TRANSCONTINENTAL GAS PIPE LINE COMPANY, LLC
PROPOSED PERMIT MODIFICATION OF EXISTING
20" AND 12" GAS PIPELINES
BLOCKS A-531, A-536, A-537, A-538, AND A-555
HIGH ISLAND AREA
GULF OF MEXICO

United States Department of the Interior
BUREAU OF SAFETY AND ENVIRONMENTAL ENFORCEMENT
 Gulf of Mexico OCS Region
 1201 Elmwood Park Boulevard
 New Orleans, LA 70123-2394

Reference is made to Transcontinental Gas Pipeline Company, LLC's (Transco) Right-of-way (ROW) decommissioning application dated June 21, 2018, and received by this office on June 22, 2018, for Pipeline Segment Number (PSN) 5451, ROW No. OCS-G04055. This application was amended with supplemental data via letter dated on April 8, 2019 and received by this office on April 10, 2019.

Reference is made to Transcontinental Gas Pipe Line Company, LLC's (Transco) Right-of-way (ROW) decommissioning application dated June 21, 2018, and received by this office on June 22, 2018, for Pipeline Segment Number (PSN) 5452, ROW No. OCS-G04055. This application was amended with supplemental data via email dated and received by this office on September 26, 2018.

SEG. #5452 - PROFILE VIEW
NOT TO SCALE

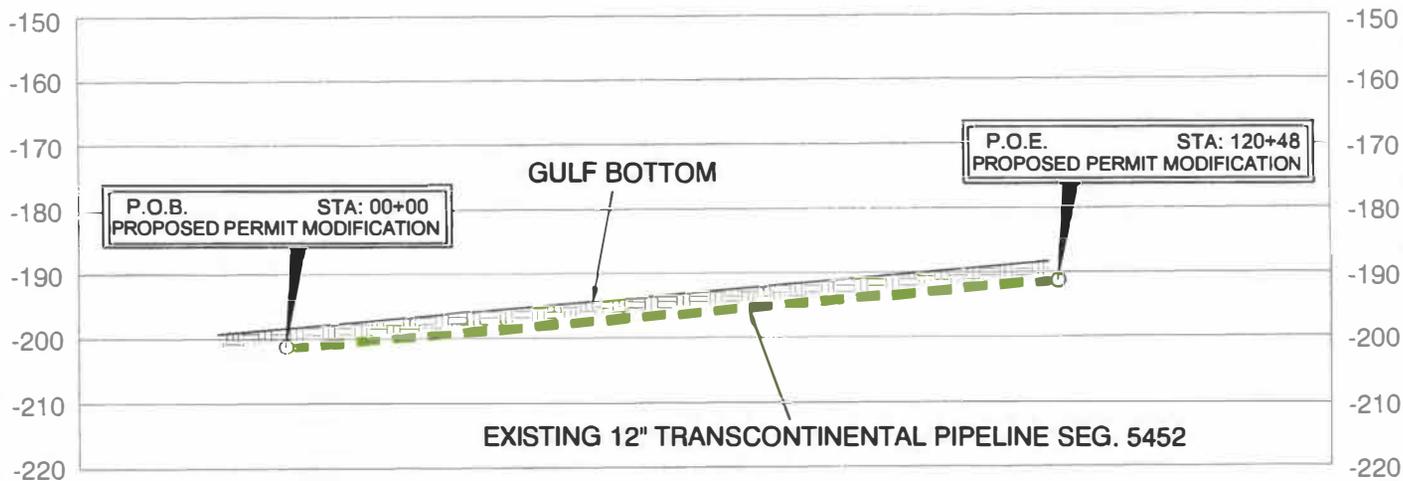
Specifically, Transco requests to decommission PSN 5452 in-place. Additionally, Transco requests to relinquish the pipeline ROW OCS-G04055.

Pursuant to 30 CFR 250.1751, Transco's request to decommission PSN 5452 in-place is hereby approved. As a reminder, pursuant to 30 CFR 250.1754, if at any time the Regional Supervisor determines that the pipeline decommissioned in-place is an obstruction, it must be removed.

SEG. #5451 - PROFILE VIEW

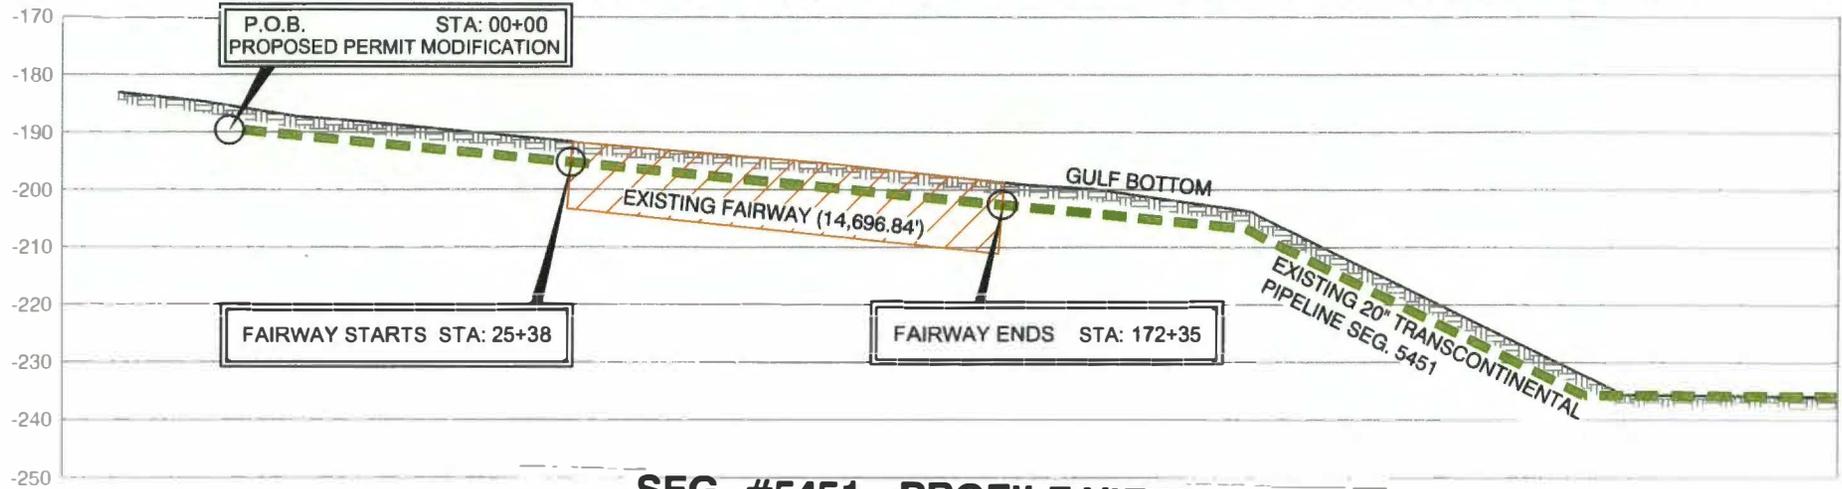
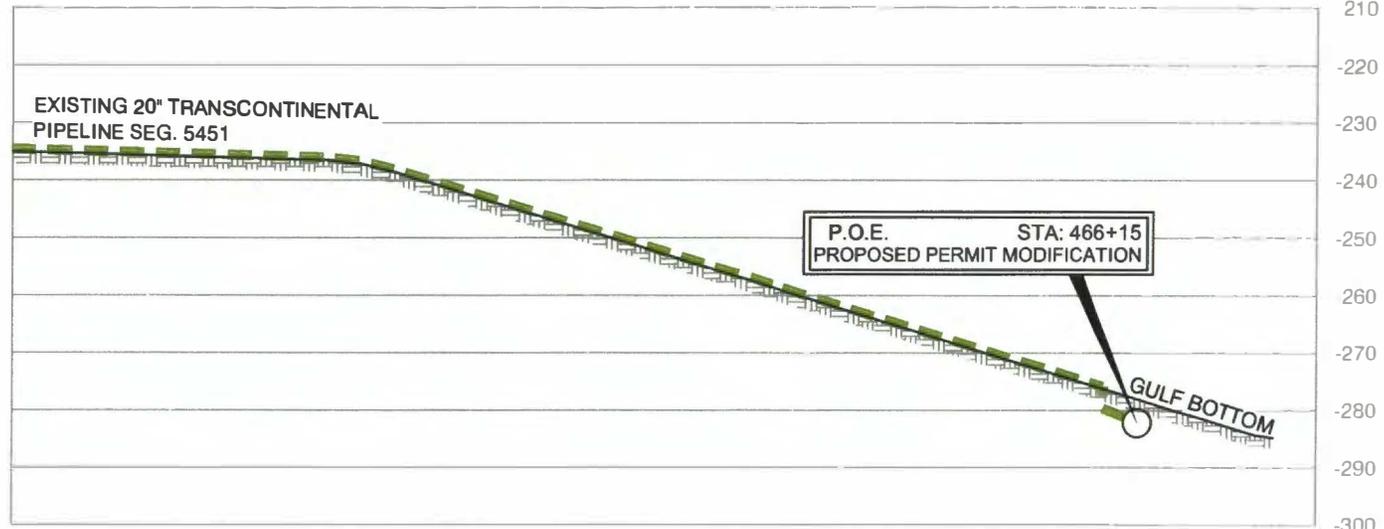
Approval to decommission PSN 5451 is subject to the United States Army Corps of Engineers (USACE) granting a concurrent approval for the aforementioned decommissioning operations. Therefore, Transco must secure USACE permission to decommission the subject pipeline segment and provide documentation of said permission to BSEE within 180 days of USACE approval or within 180 days of the date of this letter. If Transco is unable to secure USACE permission, the BSEE approval to decommission PSN 5451 in-place is revoked and Transco must submit to BSEE for approved a revised decommissioning application to decommission the entire length of PSN 5451 that traverses the fairway/anchorage area and the spans of the subject pipeline segment a distance of 500 feet beyond both edges of the fairway/anchorage area boundary must be removed in accordance with 30 CFR 250.1752.

Pursuant to 30 CFR 250.1751, Transco's request to decommission PSN 5451 in-place is hereby approved. As a reminder, pursuant to 30 CFR 250.1754, if at any time the Regional Supervisor determines that the pipeline decommissioned in-place is an obstruction, it must be removed.
